ADDENDUM NO. 4

**Indianapolis International Airport
Indianapolis, Indiana**

Belly Cargo/GSE Maintenance Building

IAA Project No. I-09-033-B

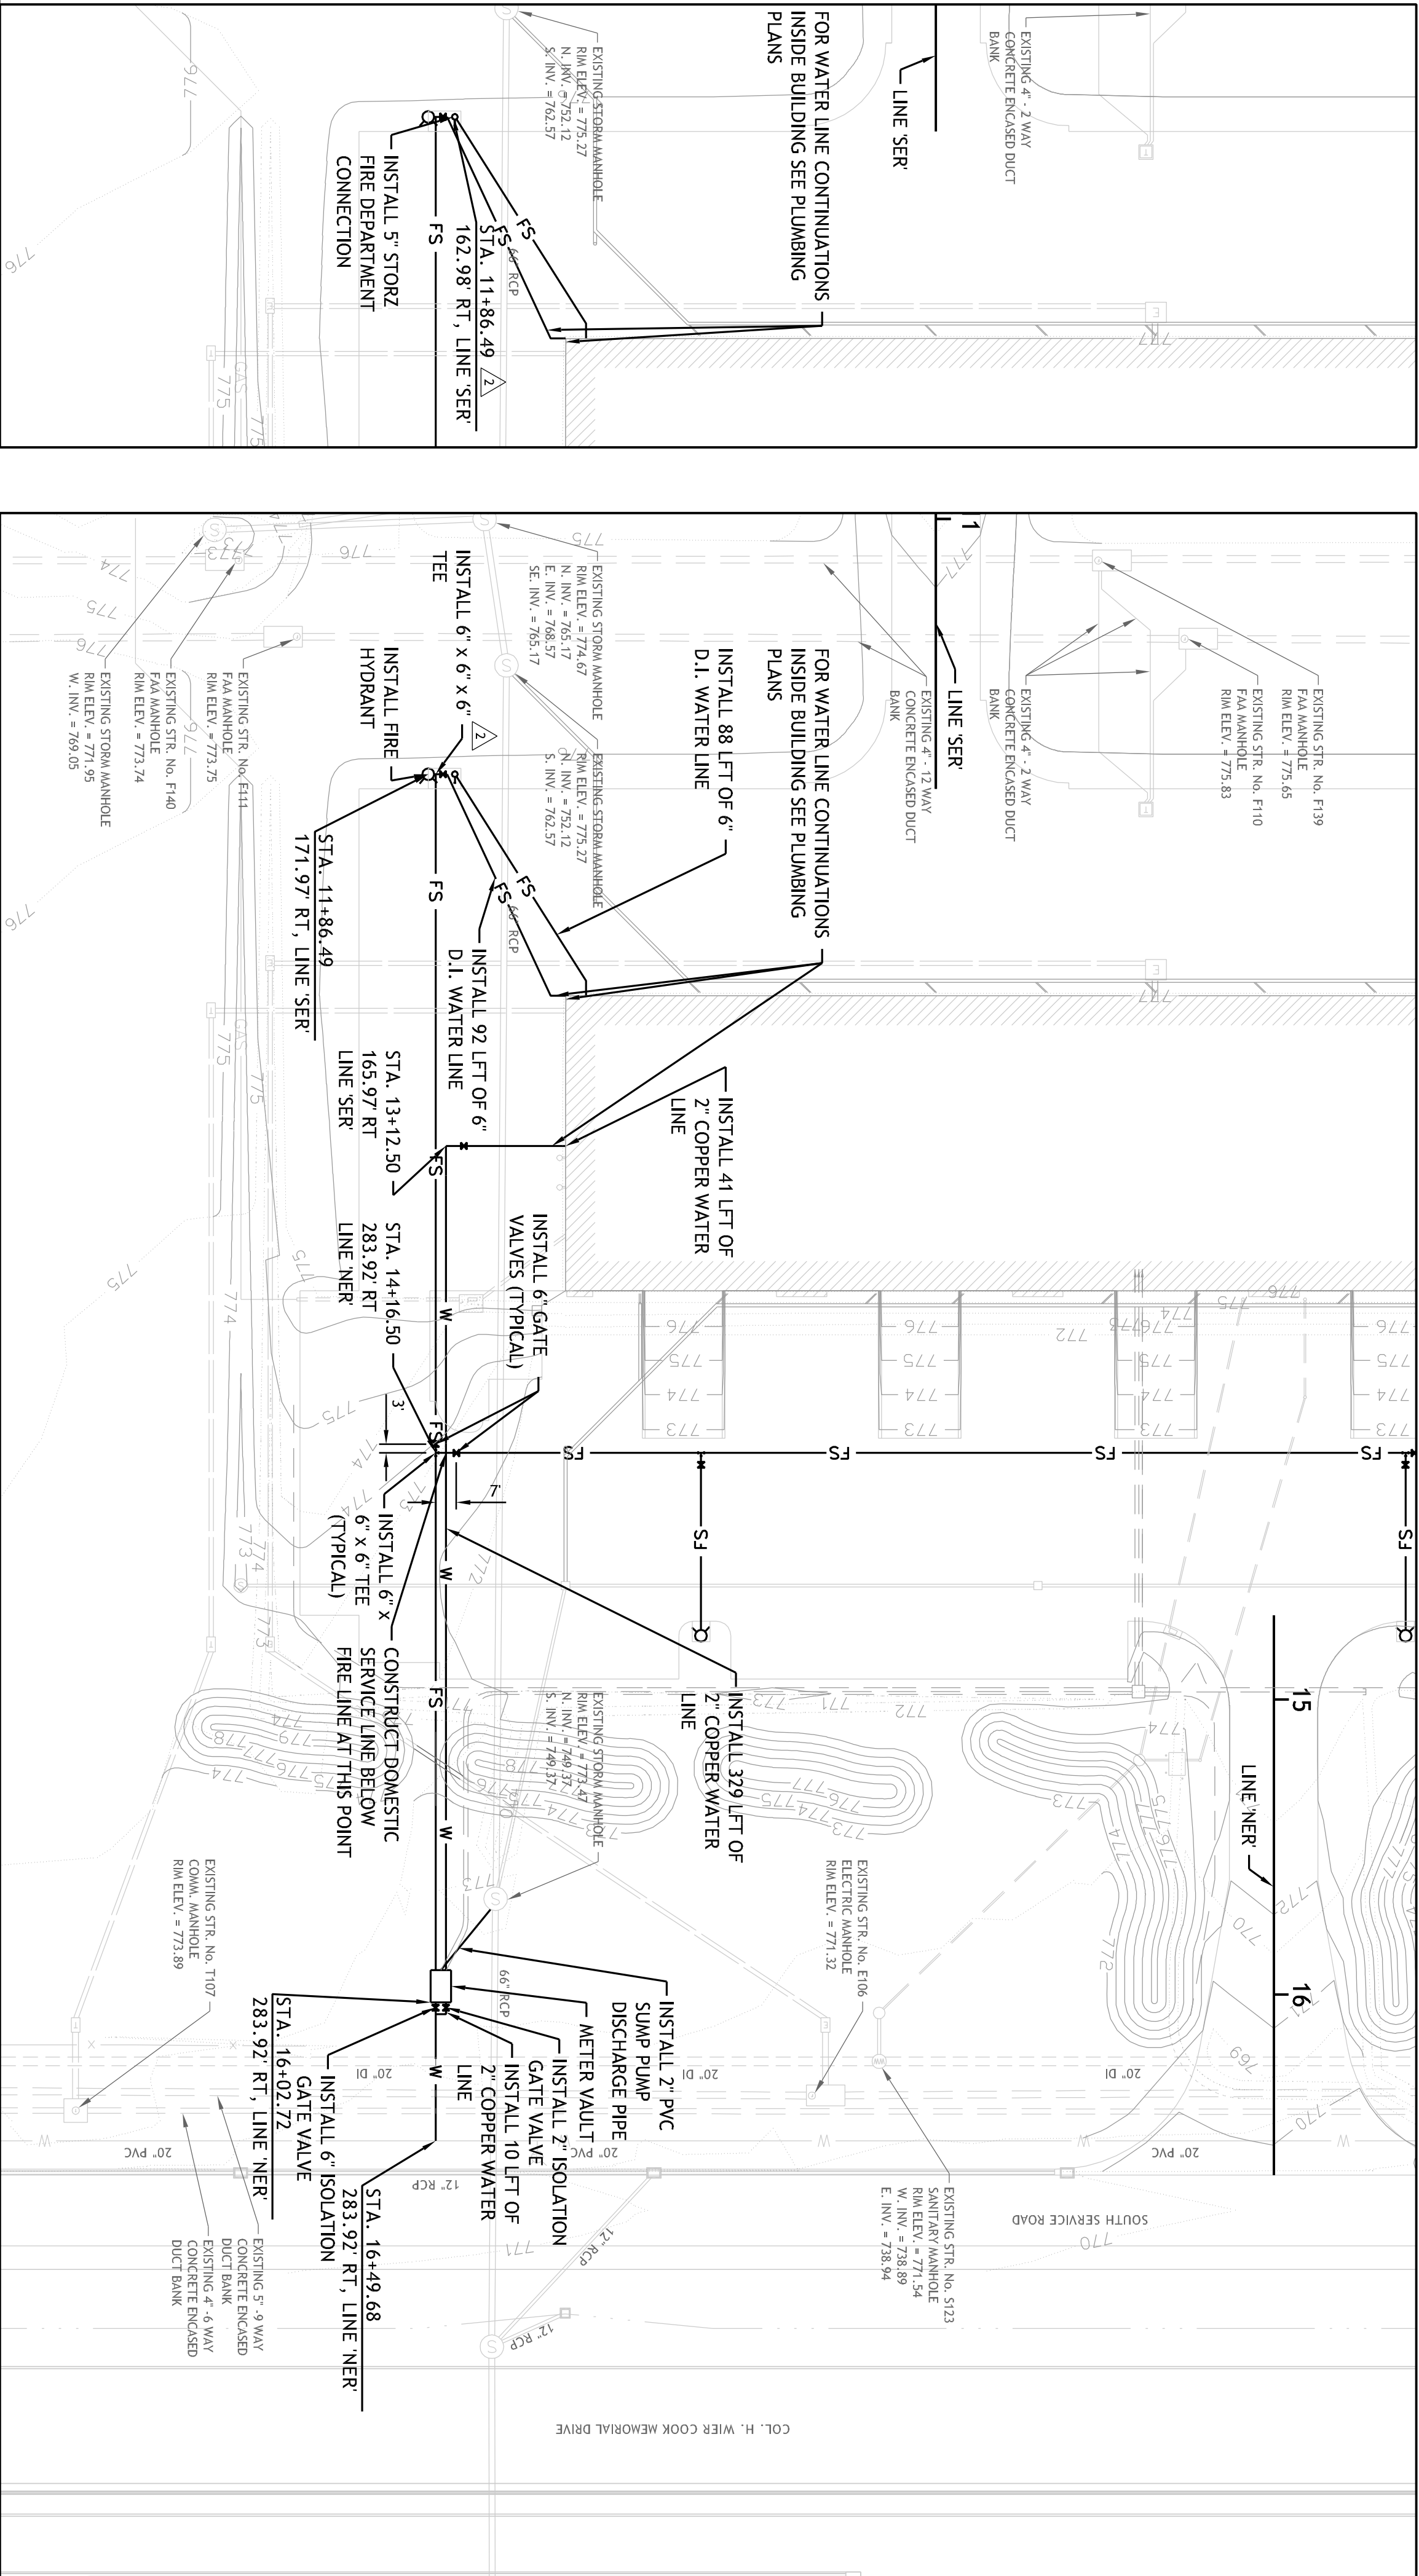
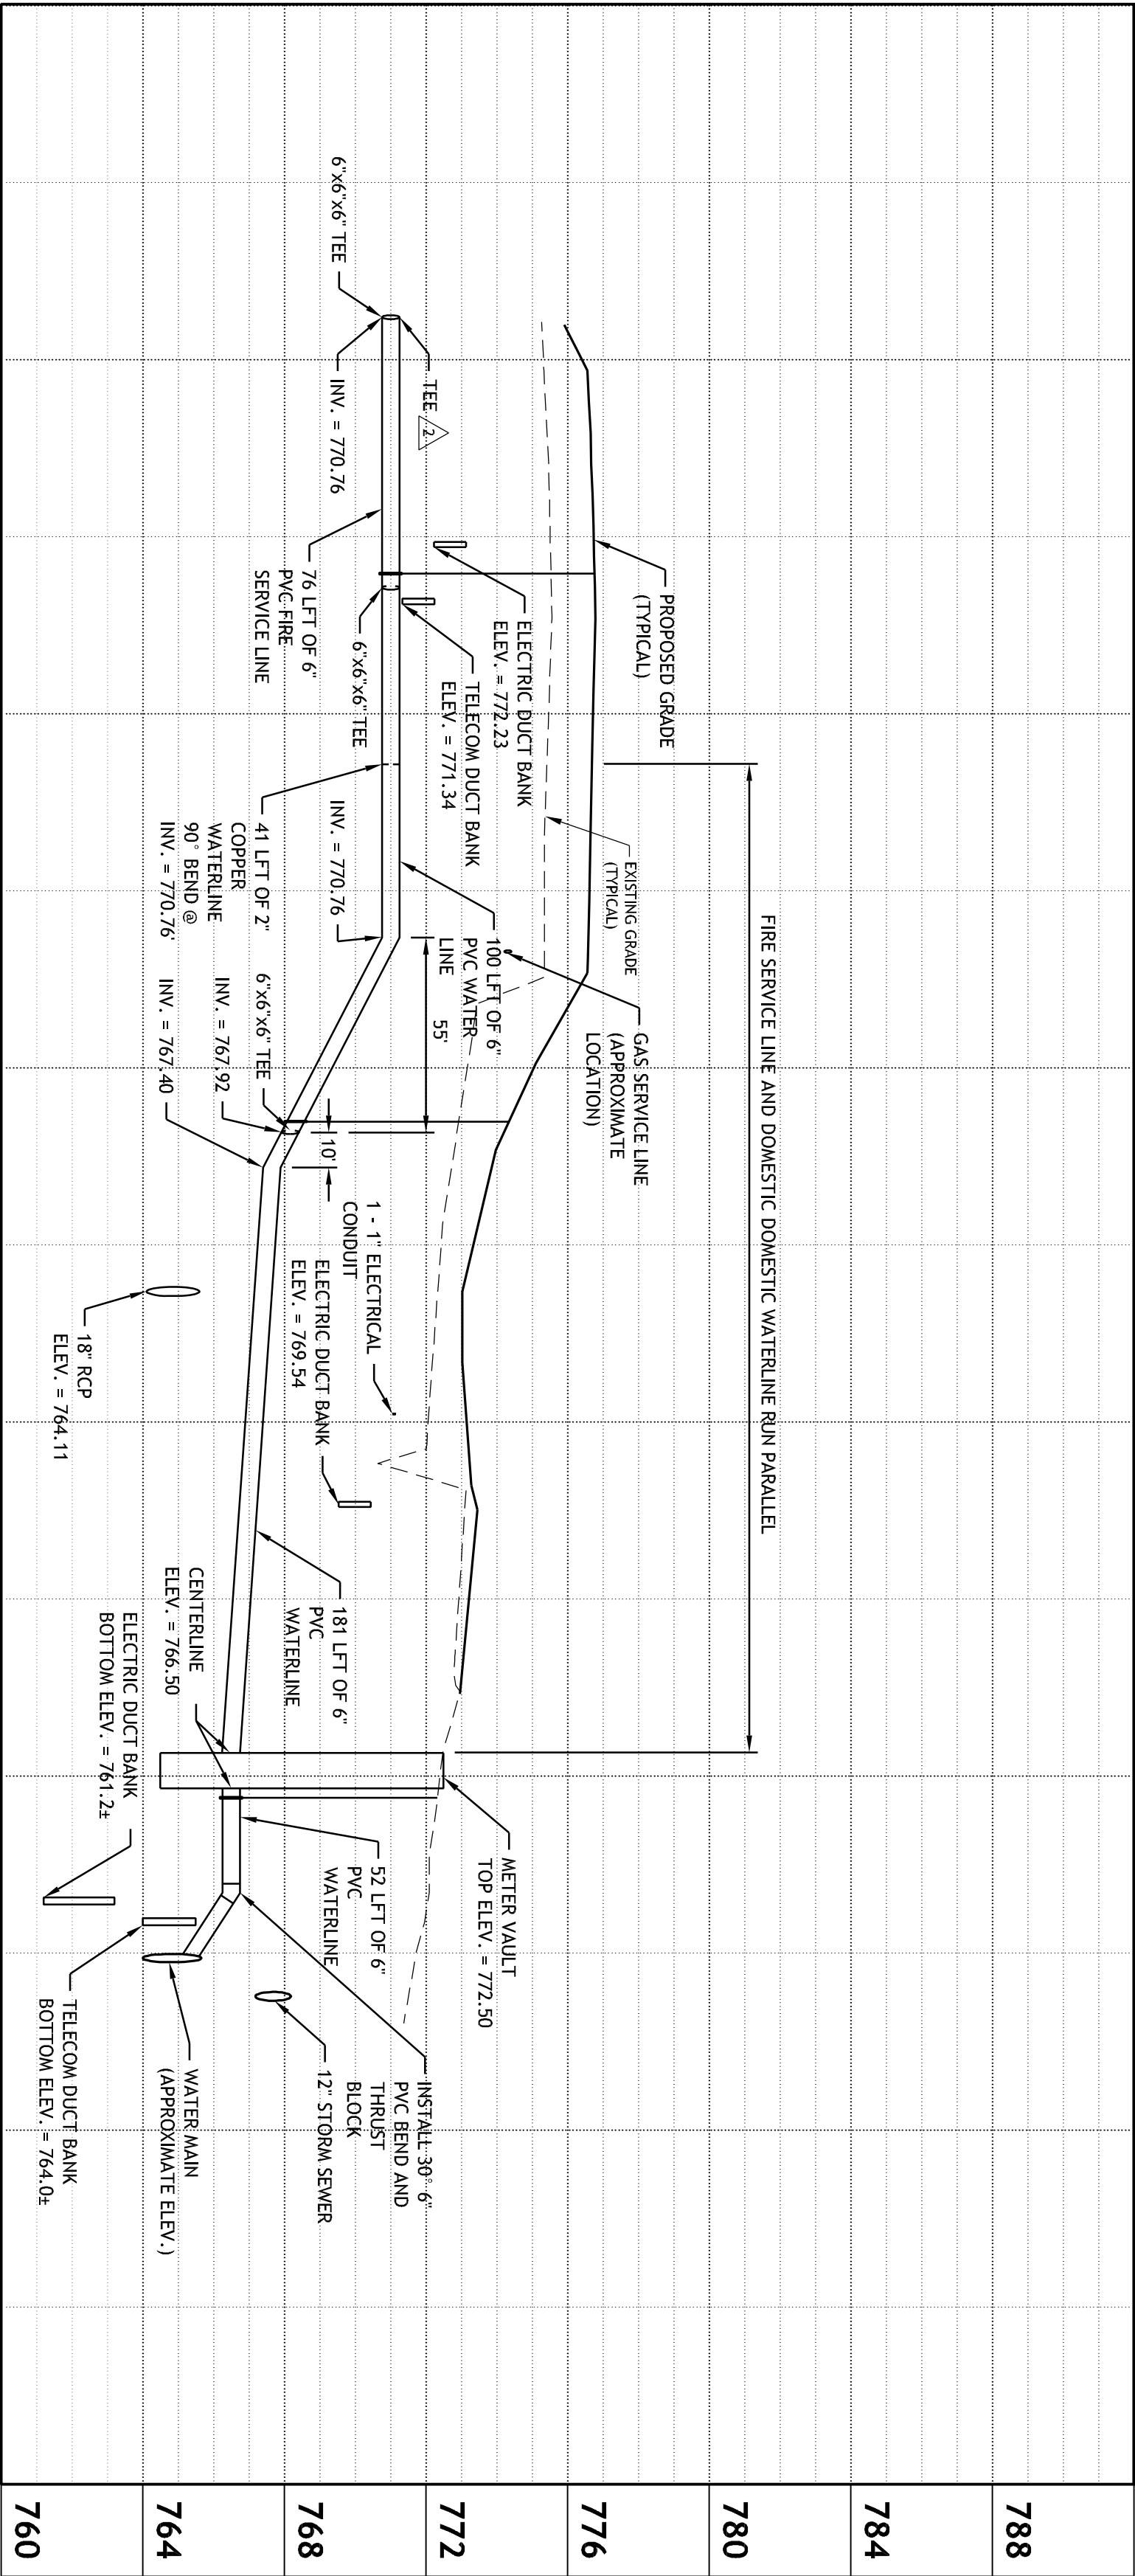
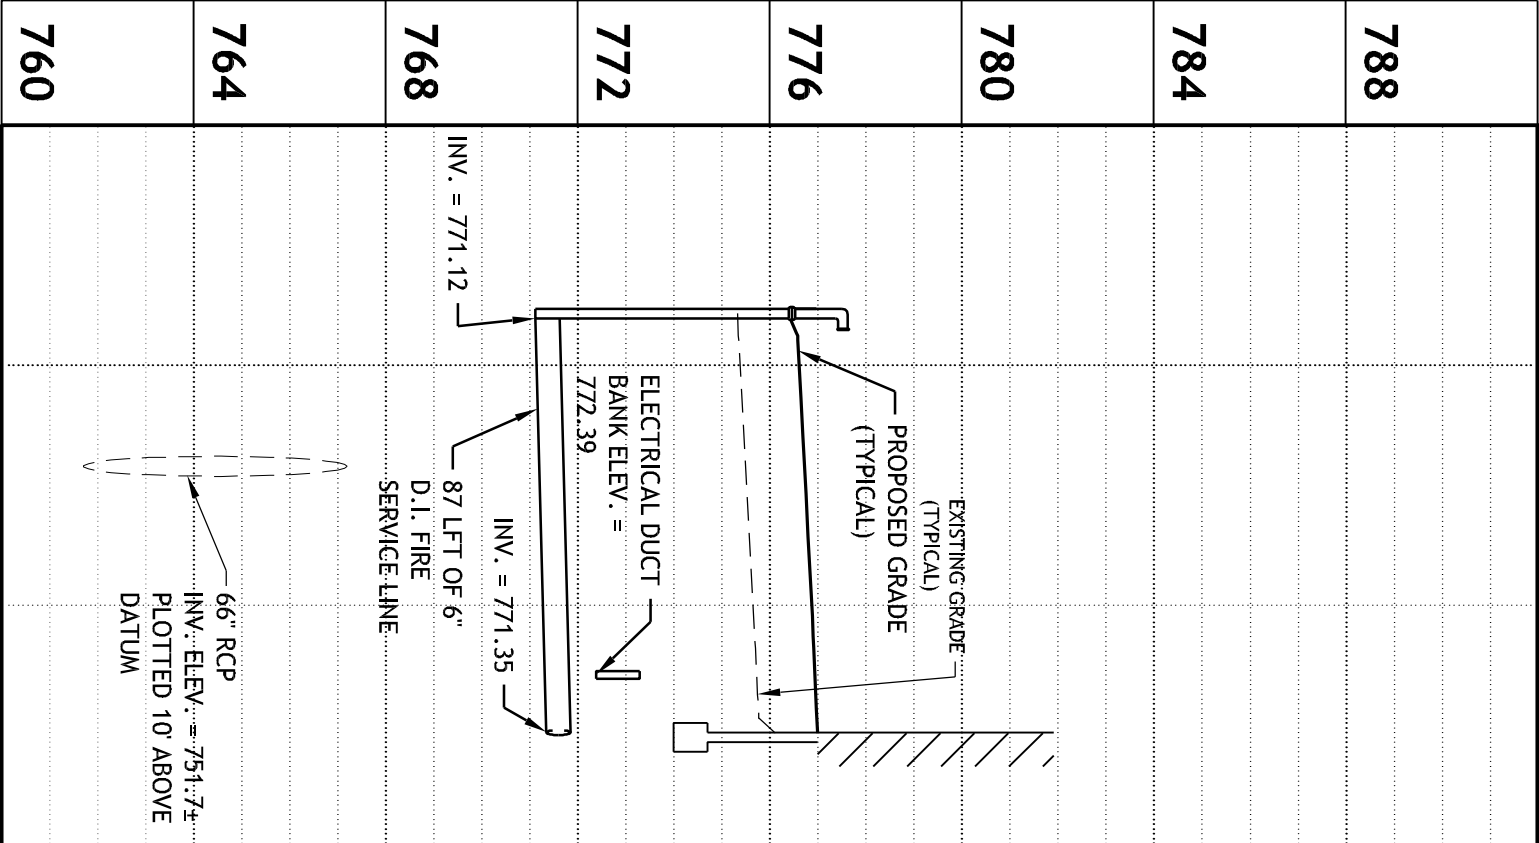
PLAN SHEET C302 – FIRE SERVICE LINE PLAN AND PROFILE LINE 'FS-1'

Delete: Plan Sheet C302, issued 10/16/09.

(Revised routing of fire service line).

Insert: Plan Sheet C302, revised 11/16/09 (attached).
